Planning & Zoning Board

Thursday, September 21, 2023

1. App# 2023-5479; 1551 Ives Avenue; Marie's House of Hope Inc.; Conditional Use
2. App# 2023-5486; 7305 E. Main Street; Richard Holmes; Variance
3. App# 2023-5487; 7305 E. Main Street; Richard Holmes; Certificate of Appropriateness

**MINUTES REGULAR MEETING
REYNOLDSBURG PLANNING & ZONING BOARD
September 7, 2023**

REVISION DATES:
1 04/05/2023
2 04/14/2023
3 05/22/2023
4 06/12/2023
5 08/21/2023

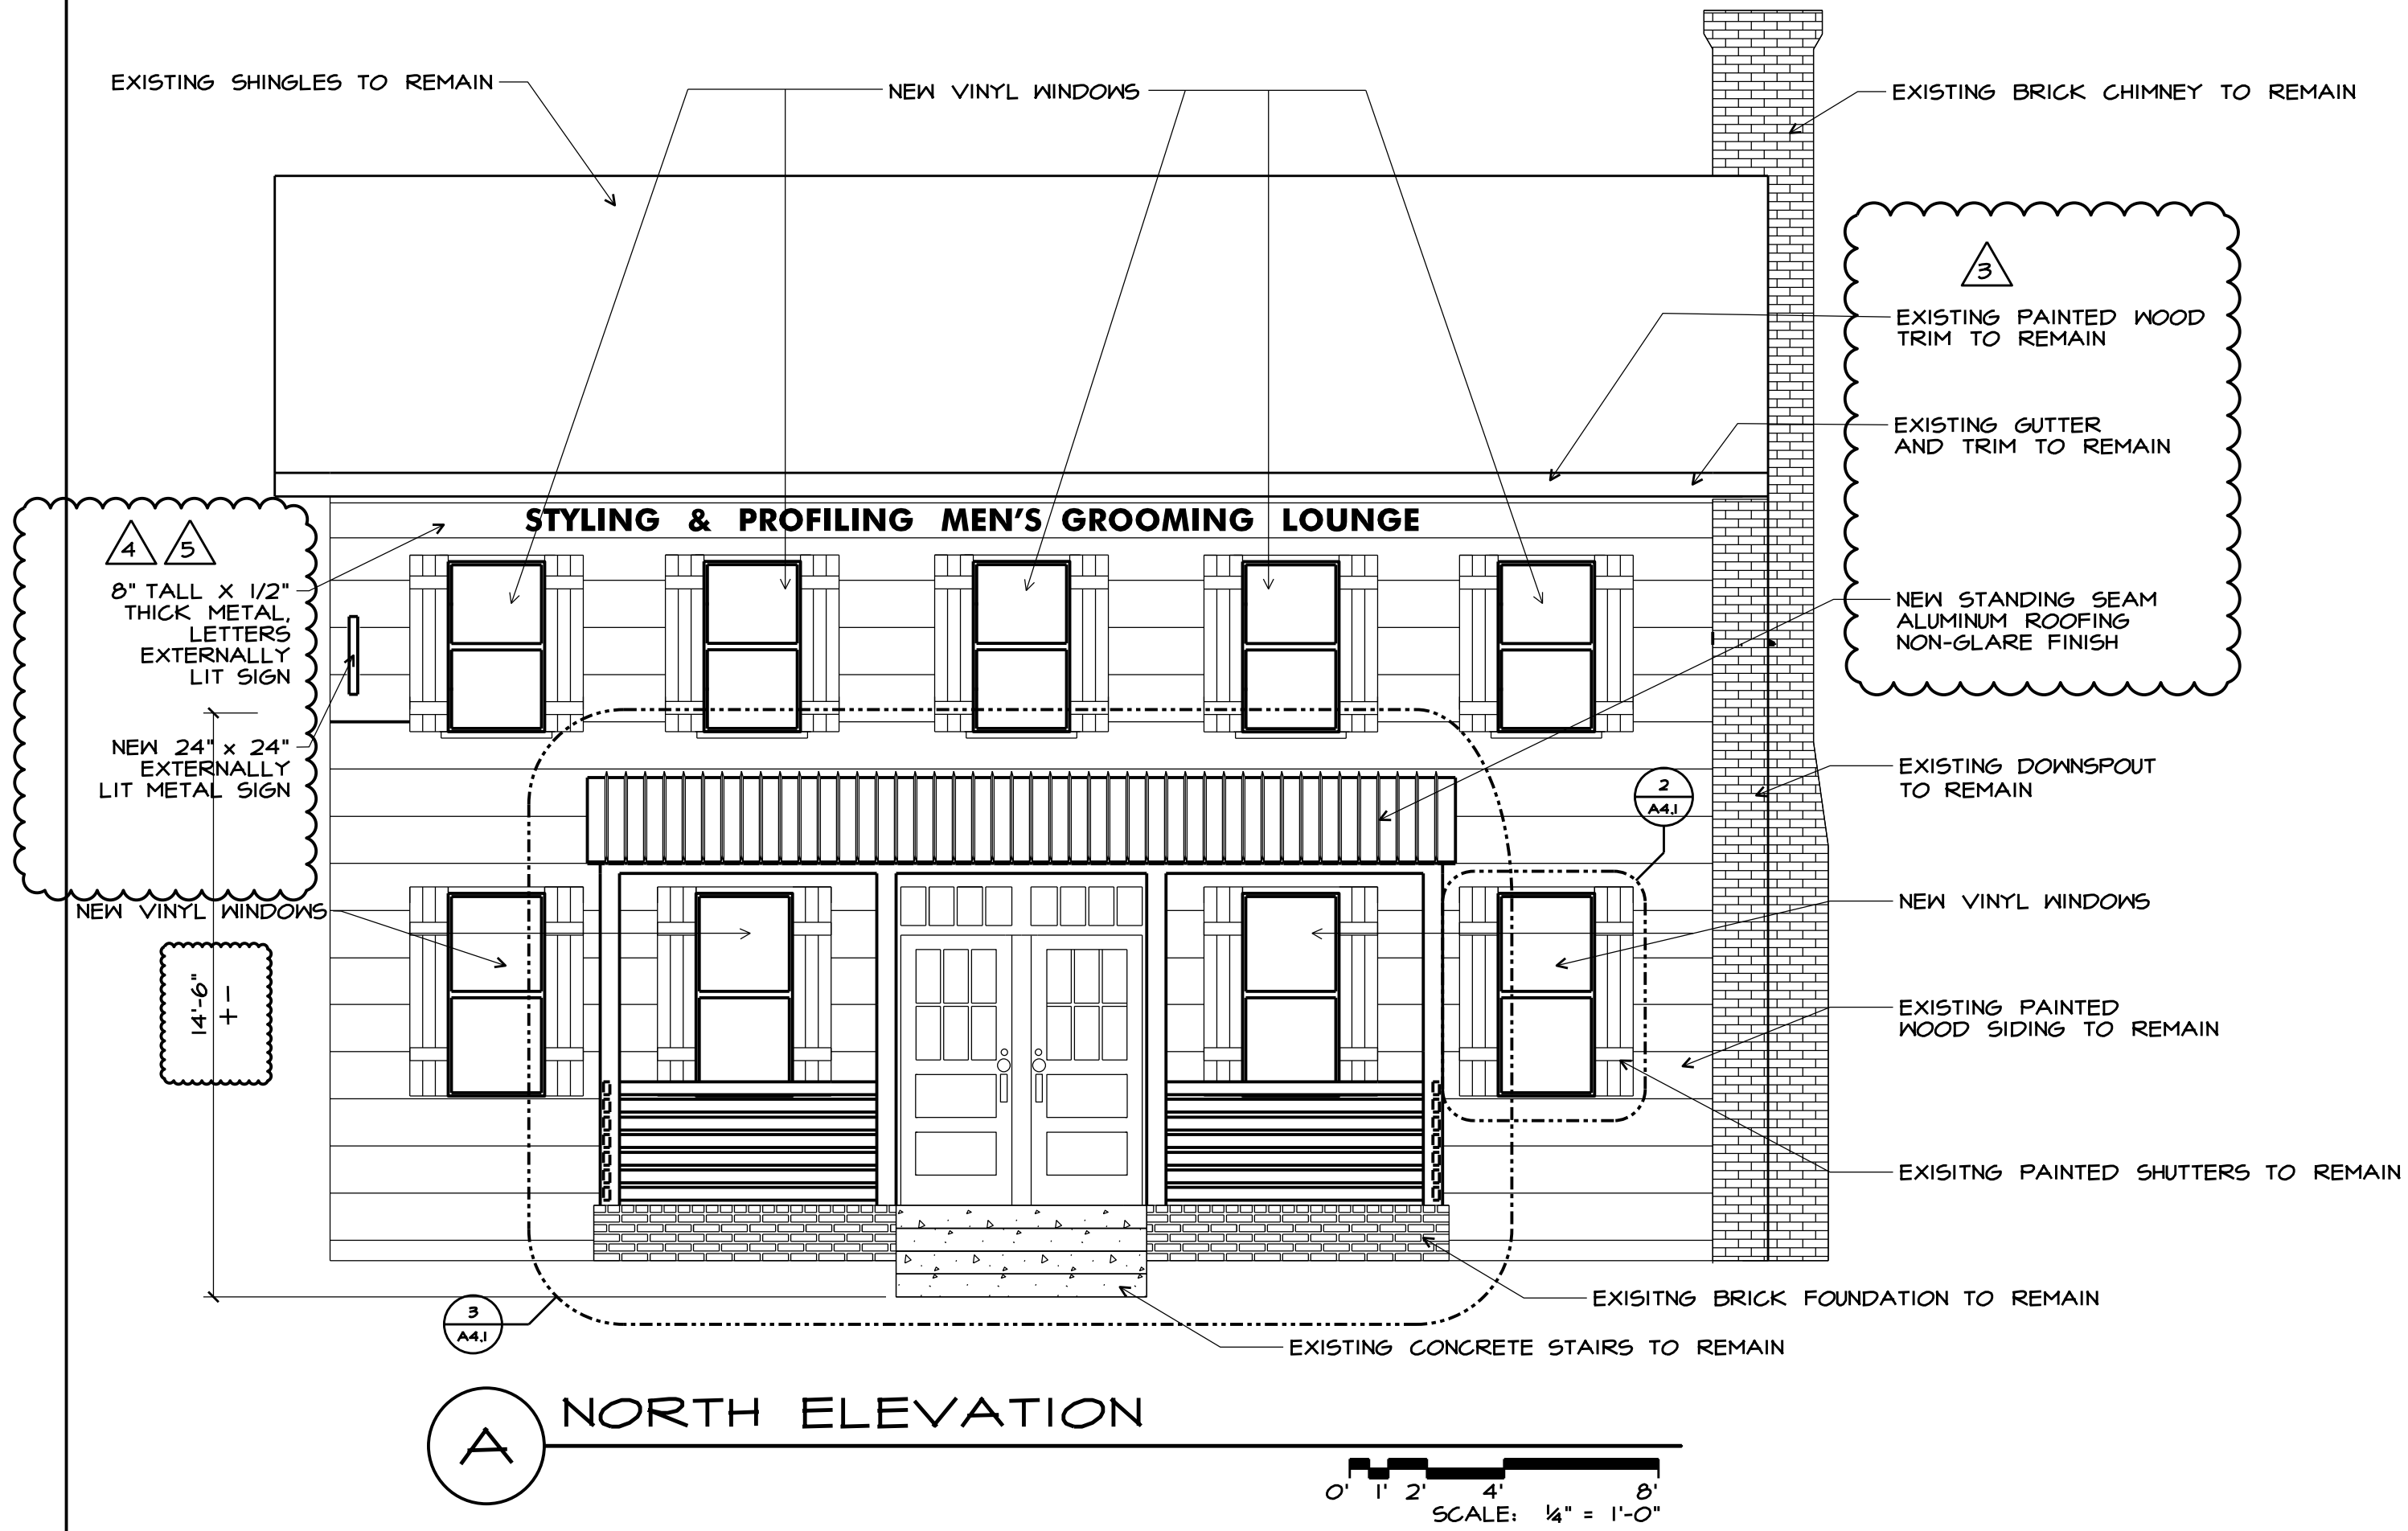
- a. No Plan B. Not provided on A-1.1. Not angled out on the sheets, needs to be clearly identified.
10. The sign plan states the sign is 48" by 48" for a total square footage of 16SF. The maximum square footage permitted of a projecting sign is 6 SF. Section 1105.03.C.v.2
